KENWOOD

SERVICE BULLETIN

PS-50 IMPROVED VOLTAGE SURGE PROTECTION

5-23-86

AVR UNIT (X43-1520-00) Component Side

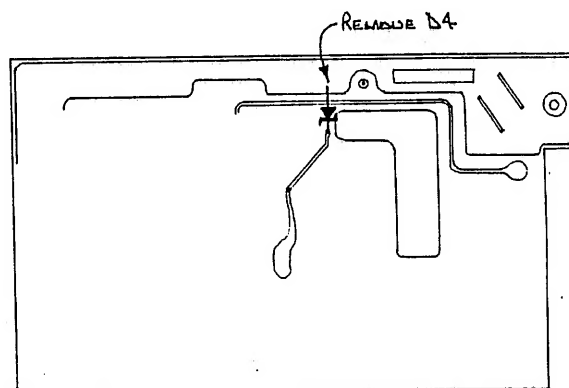
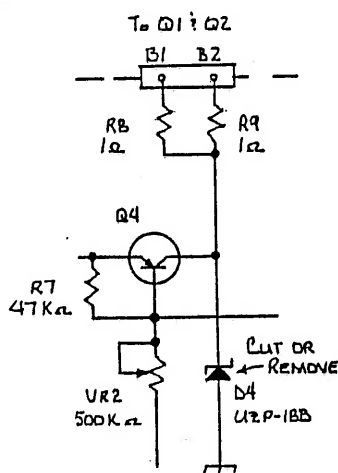
We have received a few reports regarding the loss of transistor Q4, resistors R2, and R3, and zener diode D4 on the AVR UNIT. Apparently a voltage surge on the power input might cause D4 to short. If this occurs the surge current thru resistors R2 and R3 could be high causing the failure of the two resistors and Q4.

On the AVR UNIT (X43-1520-00) open or remove diode D4. The drawings below show the location of this component.

If you receive a unit with no output voltage check D4, R2, R3, and Q4. You should replace R2, R3, and Q4 if there is any sign of damage to any of these components.

This change applies to units with serial numbers before 7040001.
Time required for this modification is 1/2 hour or less.
(c) 52386TKCCLM
